RANCHO SANTIAGO COMMUNITY COLLEGE DISTRICT

ADDENDUM NO. 2

Bid #1506
ORANGE EDUCATION CENTER PORTABLES PHASE II
at
ORANGE EDUCATION CENTER

Project ID #3762, DSA #04-125366

**FLOOR PLAN
PORTABLE 201, 202**

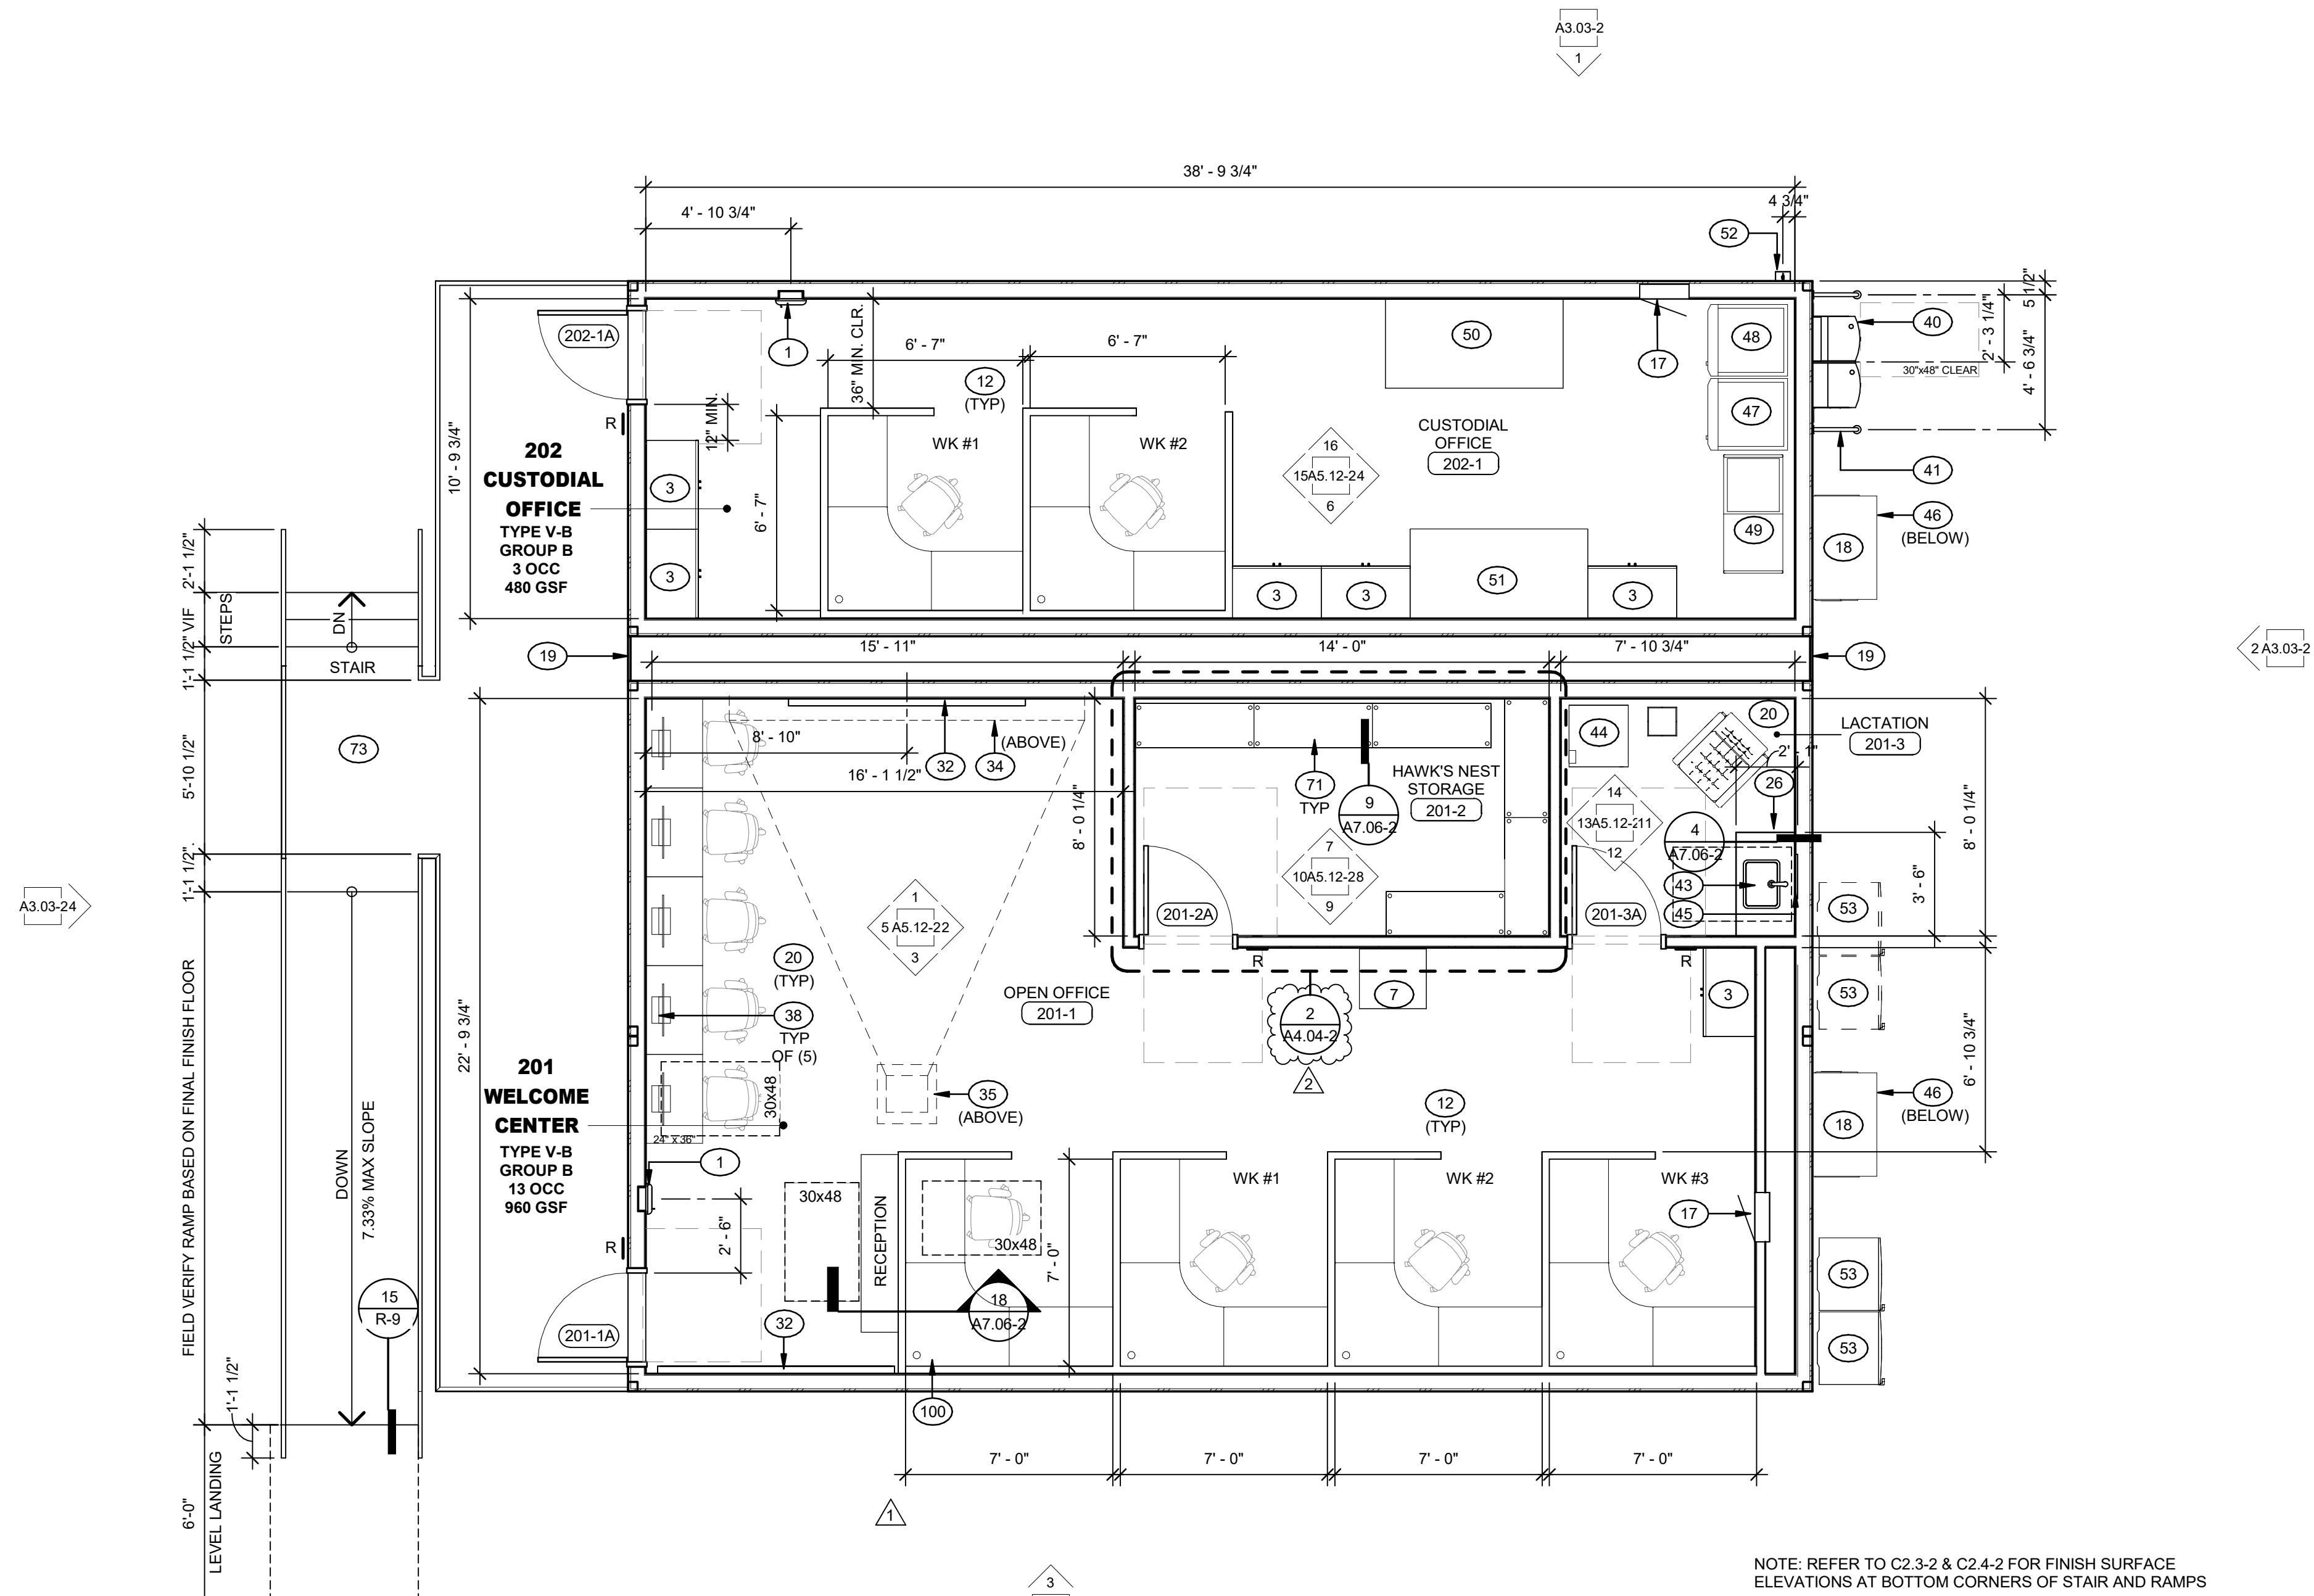
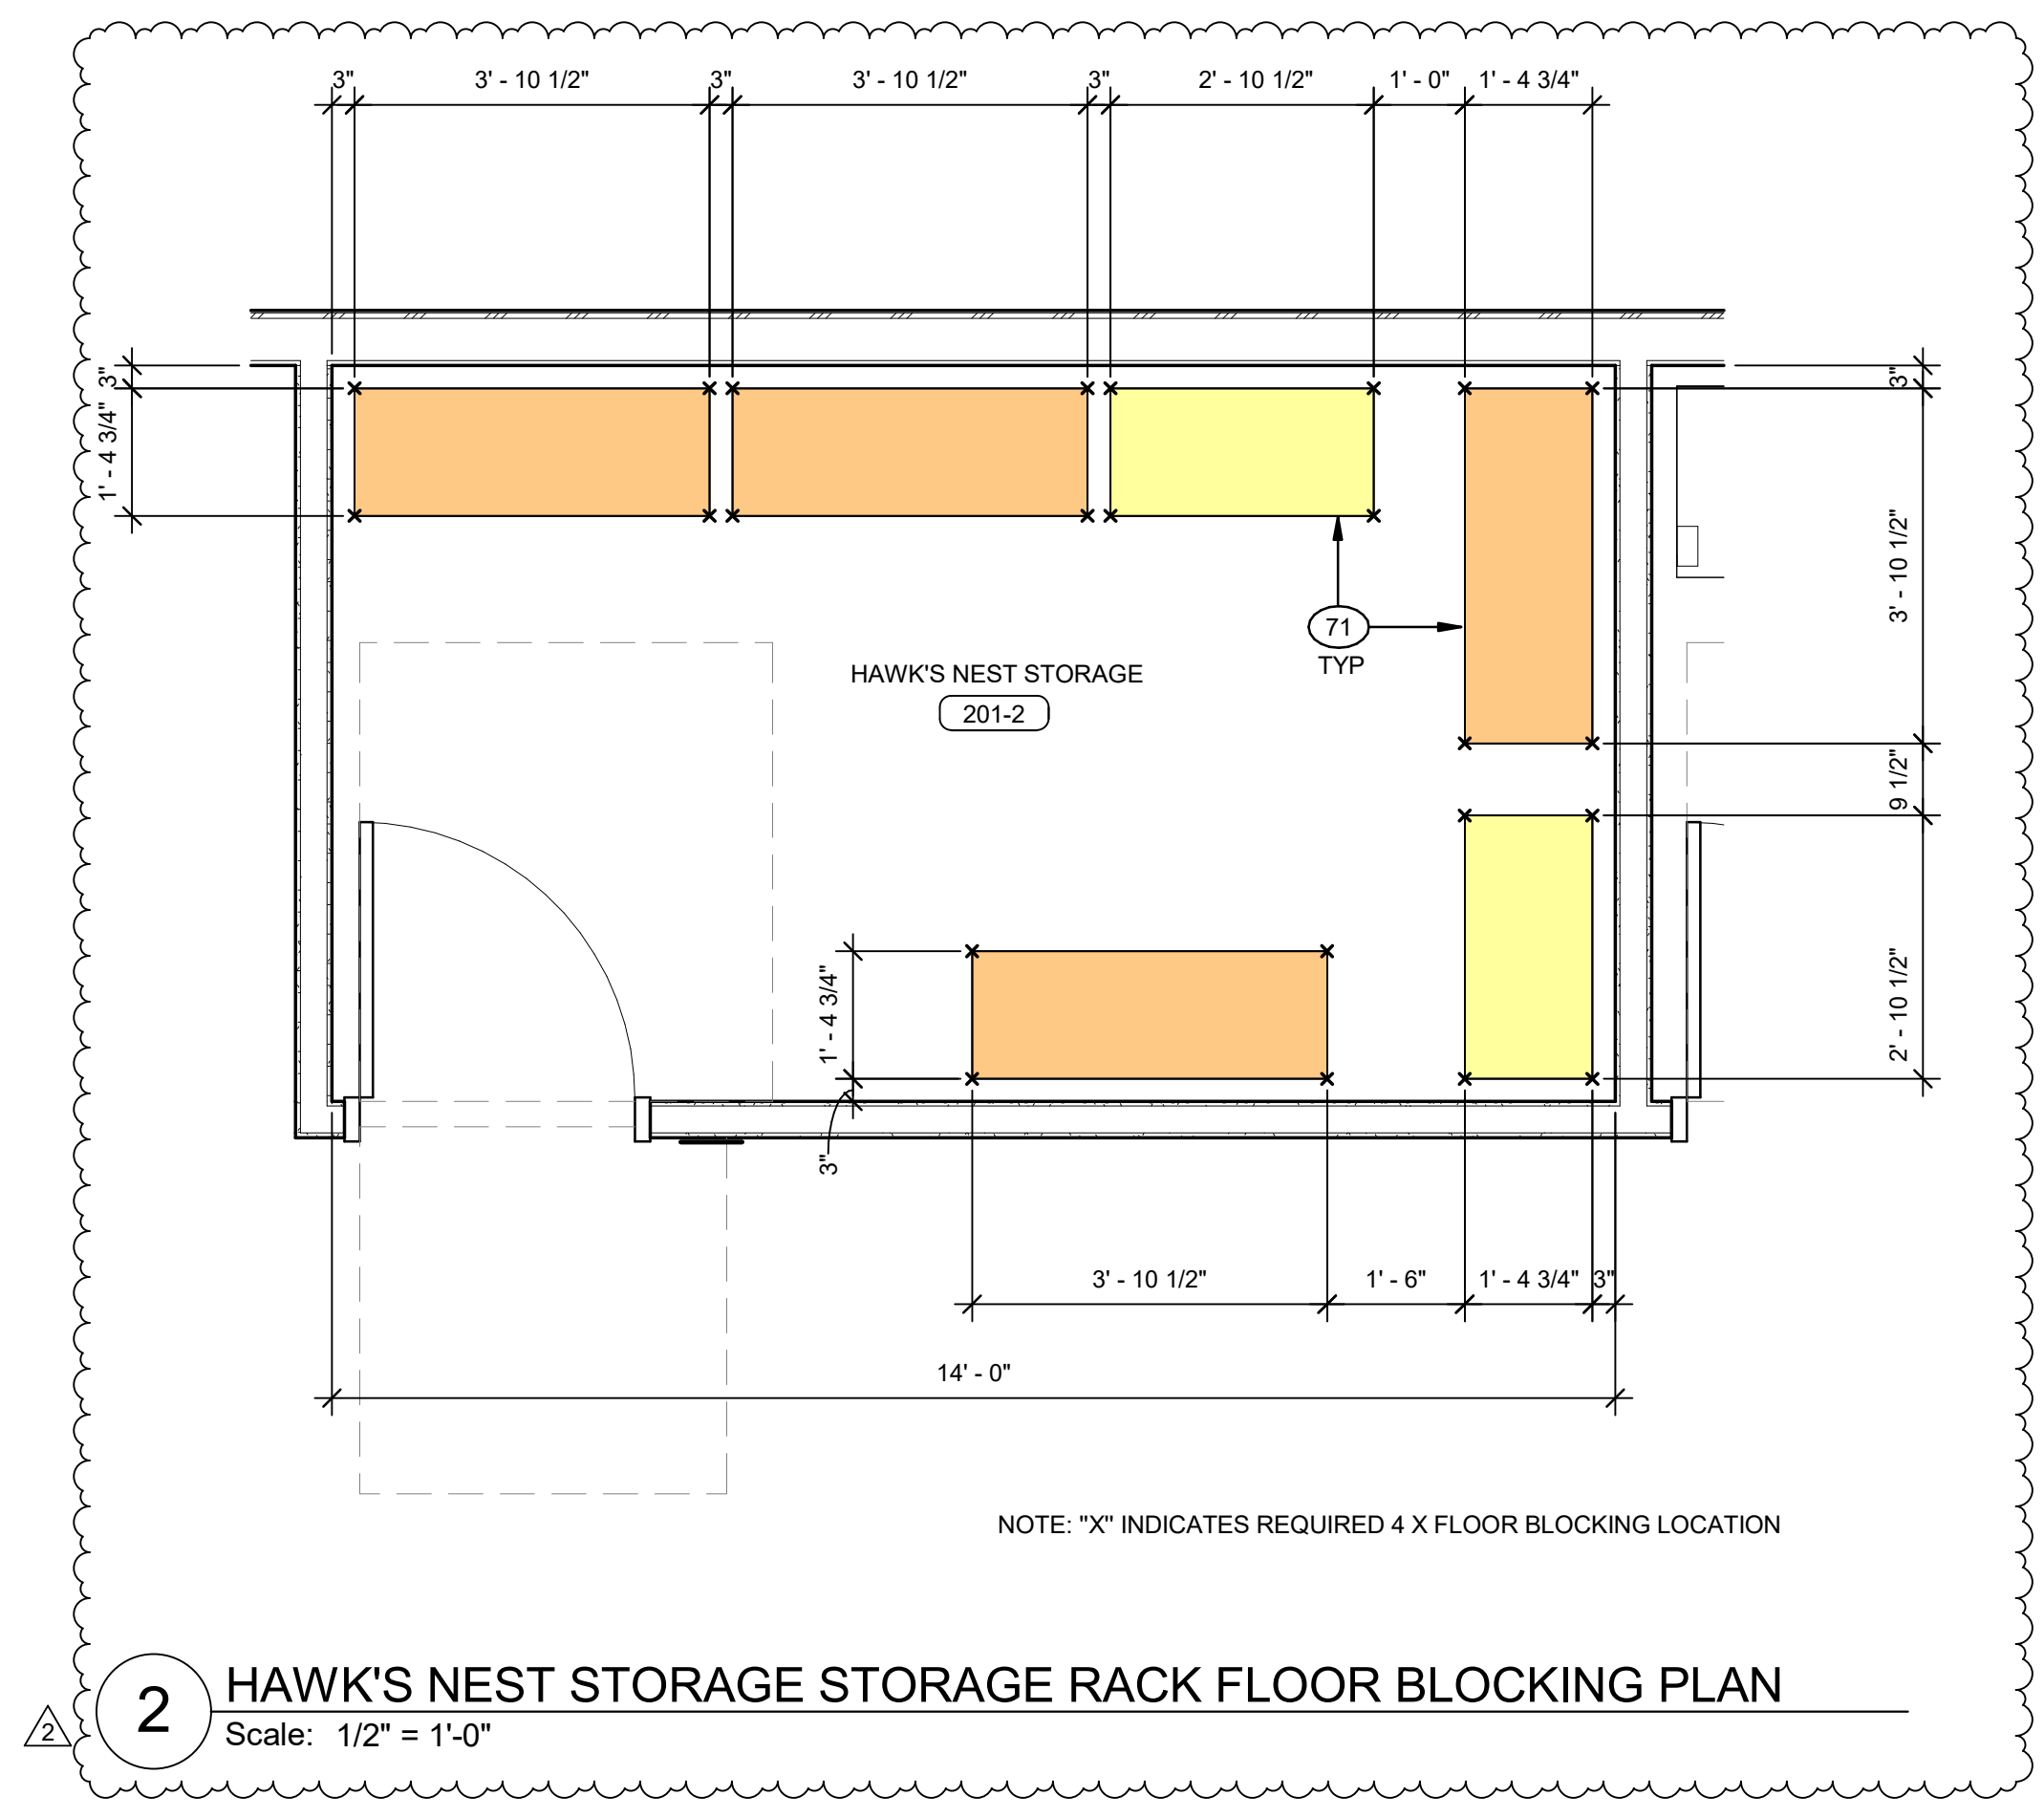
5. A4.04-2, FLOOR PLAN PORTABLE 201 – 202

Added “Hawk's Nest” Storage, Room 201-2, Storage Rack Floor Anchorage Location as indicated in attached Addendum Dwg. A4.04-2.
